**PRINCE SOLMS PARK  
100 Liebscher Drive  
New Braunfels, TX 78130**

# Prince Solms Park

Oct 14, 2019

# City of New Braunfels ADA Transition Plan

## #47 Priority 1: Accessible Routes

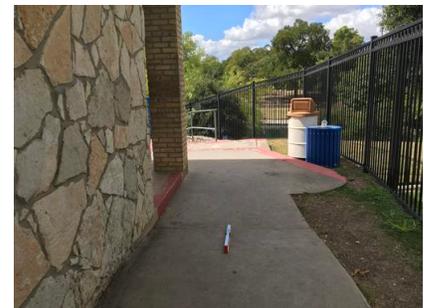
The sidewalk leading from the loading zone to the admission window has a running slope of approximately 11.5% as it nears the admission window and an approximate 1/2-inch vertical change in level due to heaving.

Recommendation: Remove and replace approximately 15 feet of sidewalk (75 s.f.) and create a route flush with the admission window step. See Item #71 for additional route requirements at this building.

## #83 Priority 1: Accessible Routes

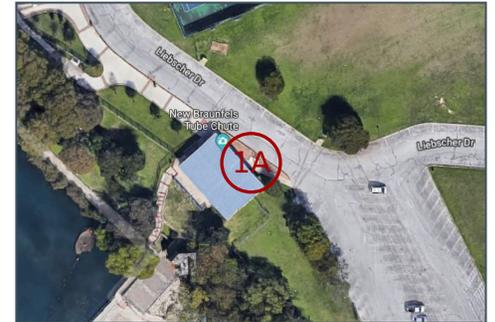
The sidewalk leading from the accessible parking space has a change in level of greater than 1/2-inch due to heaving.

Recommendation: Grind edge to ease transition.

## #84 Priority 1: Curb Ramps

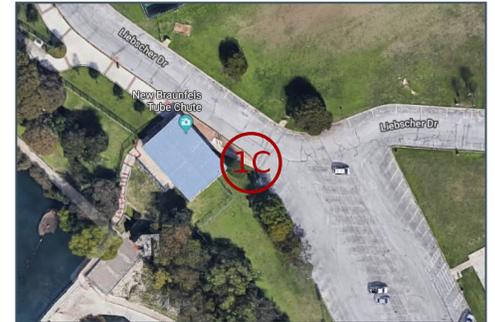
The curb ramp leading from the accessible parking space has a cross slope up to 8.2% and a running slope up to 10%. No flush transition is provided at the bottom, and the top landing and sidewalk has a cross slope of approximately 3%.

Recommendation: Remove and replace the curb ramp and approximately 15 feet (75 s.f.) of sidewalk at the top of the ramp.

## #54 Priority 1: Parking

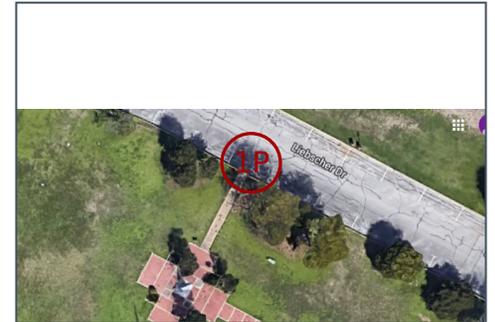
No accessible parking is provided near the veterans memorial.

Recommendation: Add one accessible parking space on the shortest accessible route to the memorial. Remove grass area and expand paving to create a minimum 5-foot wide access aisle adjacent to the parking space. Install a vertical sign.

## #87 Priority 1: Parking

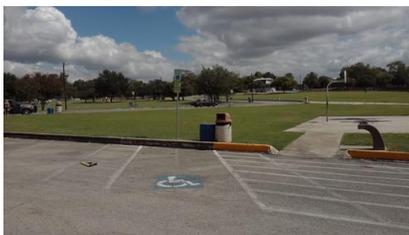
- 1) Both parking spaces and the access aisle have an approximate 3.4% to 4.4% cross slope in the north/south direction.
- 2) The northernmost parking space meets the requirements for a van space, but no van sign is provided.

Recommendation: Regrade and restripe accessible parking to have a maximum 2% slope in all directions. Add a van designation sign to the northernmost space.

## #55 Priority 2: Accessible Routes

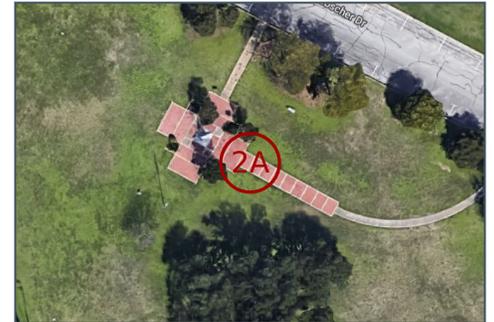
There are changes in level of up to 1-inch in some locations between the concrete bands and memorial brick pavers and between some of the brick pavers.

Recommendation: Remove and reinstall brick pavers (approximately 1400 s.f.), replacing base as necessary.

## #56 Priority 2: Accessible Routes

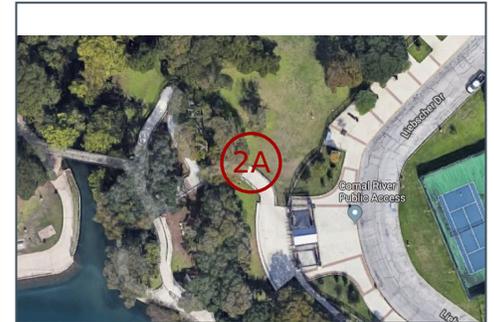
The route to the disc golf course from the sidewalk has a change in level of approximately 3 inches between the sidewalk and the grass surface.

Recommendation: Install a ramp with a slope of no more than 1:12 that dives beneath the grass and dirt surface to accommodate erosion.

## #57 Priority 2: Accessible Routes

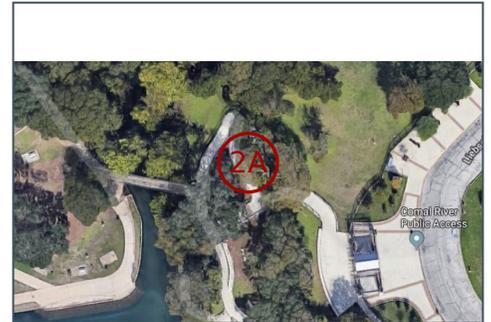
The route to the disc golf course from the sidewalk has a change in level of approximately 3 inches between the sidewalk and the grass surface.

Recommendation: Install a ramp with a slope of no more than 1:12 that dives beneath the grass and dirt surface to accommodate erosion.

## #79 Priority 2: Accessible Routes

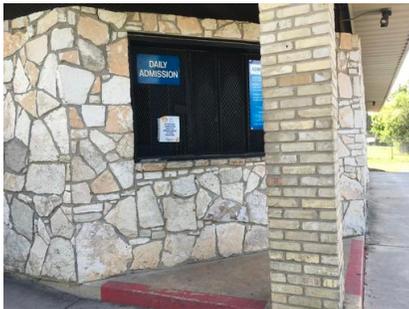
A 5-inch high step is provided at the admission counter.

Recommendation: See Item #47 for recommended correction.

## #88 Priority 2: Accessible Routes

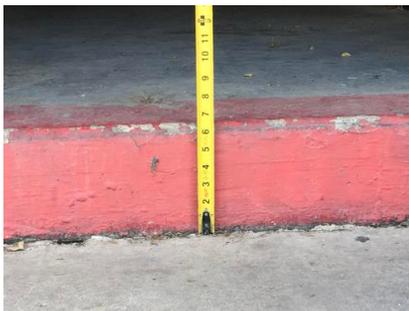
There is a 6-inch step into the building for access to First Aid and restrooms.

Recommendation: Build up sidewalk to match the elevation of the curb between the admissions counter and the building entrance for approximately 25 feet (125 s.f.). See Item #47 for related comments.

## #80 Priority 2: Counters

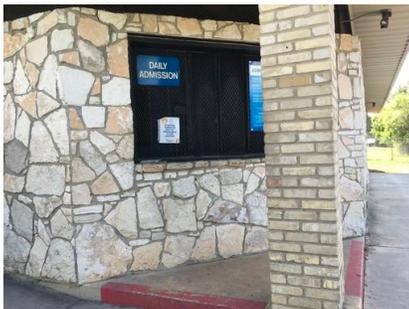
The admission counter measures 42 inches high to the top.

Recommendation: Create an accessible counter that is at least 36 inches wide and no more than 36 inches high with a 30"x48" clear floor space for a parallel approach.

## #94 Priority 2: Signs

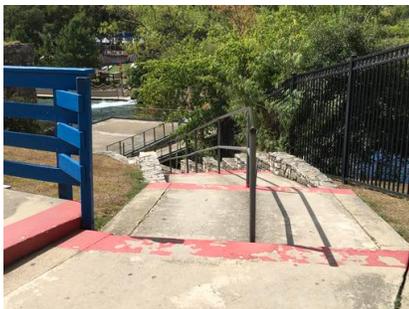
The main route from the Tube Chute Building to the river is not accessible. No sign is provided that directs users to the accessible route.

Recommendation: Add a sign with the International Symbol of Accessibility that directs guests to the location of the accessible route via the Gateway.

## #70 Priority 3: Shower

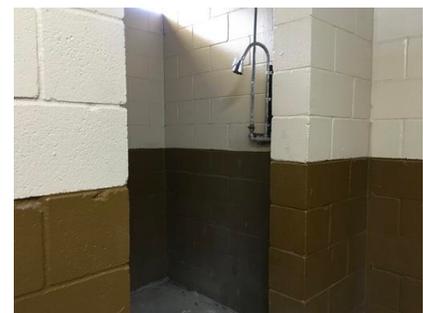
No accessible shower is provided. Existing showers measure approximately 86 inches wide and 66 inches deep. There is an approximate 1- to 2-inch change in level at the opening.

Reconfigure showers to provide a new accessible roll-in or transfer shower. Ensure a maximum 1/2-inch threshold.

## #77 Priority 3: Shower

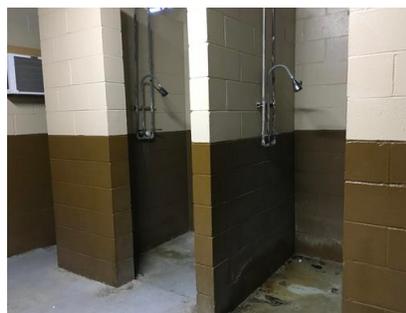
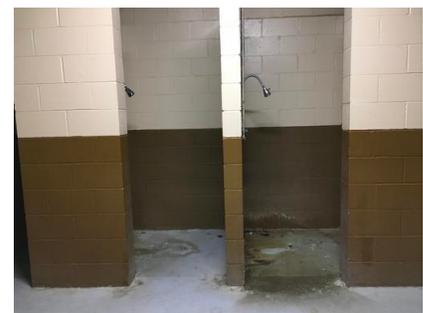
No accessible shower is provided. Existing showers measure approximately 46 inches wide and 50 inches deep. There is an approximate 1-inch change in level at the opening.

Reconfigure showers to provide a new accessible roll-in or transfer shower. Ensure a maximum 1/2-inch threshold.

## #72 Priority 3: Protruding Object

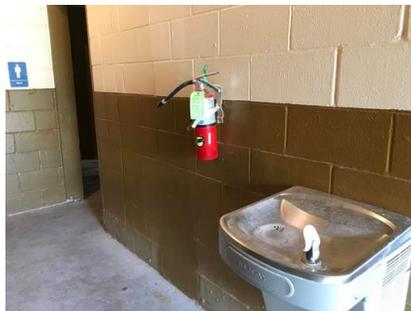
The wall-mounted fire extinguisher protrudes approximately 5 inches at 37 1/2 inches high.

Recommendation: Lower the bracket so that the bottom of the extinguisher is no higher than 27 inches.

## #66 Priority 3: Reach Range

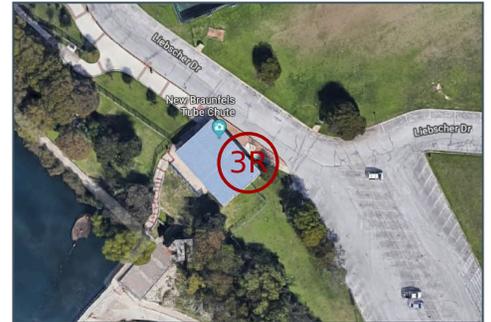
The soap dispenser at the accessible lavatory is mounted 48 high to the dispenser. For a forward reach over an obstruction, a maximum height of 44 inches is allowed.

Recommendation:  
Reposition the dispenser so that the center of the button is no higher than 44 inches.

## #74 Priority 3: Reach Range

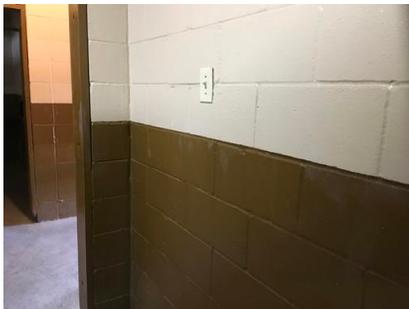
The light switch is centered at 56 inches high.

Recommendation: Lower light switch so that the top of the switch is no higher than 48 inches.
